MILITARY SPECIFICATION

SEMICONDUCTOR DEVICE, DIODE, SILICON, POWER RECTIFIER
TYPES 1N3164, 1N3168, 1N3170, 1N3172, 1N3174, 1N3175,
1N3176, 1N3177, AND R TYPES, JAN, JANTX, JANTXV

This amendment forms a part of Military Specification MIL-S-19500/211B, dated 18 May 1983, and is approved for use by all Departments and Agencies of the Department of Defense.

FIGURE 1. Physical dimensions for semiconductor devices.

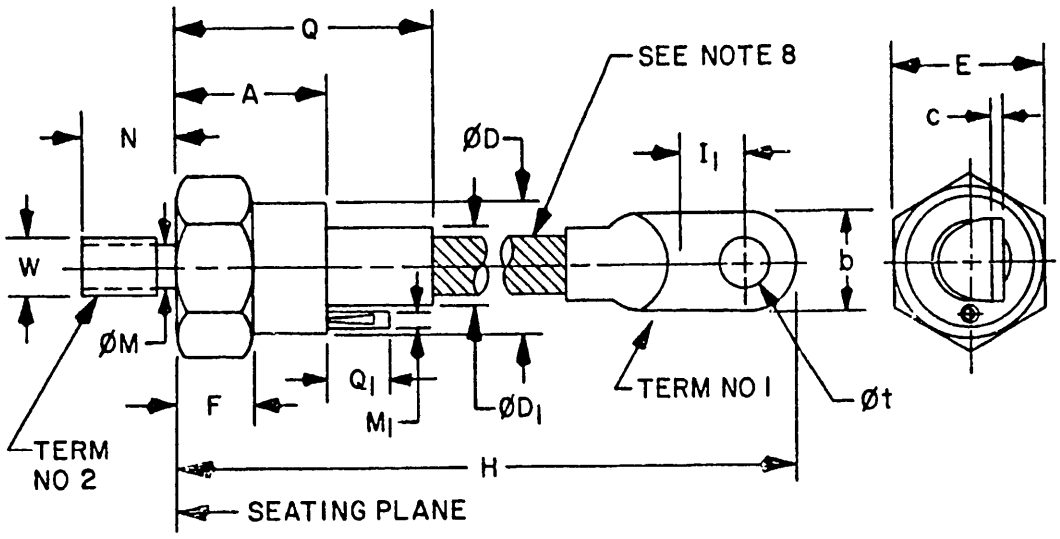
FIGURE 1: Delete and substitute new figure 1 as printed on page 3 of this amendment.
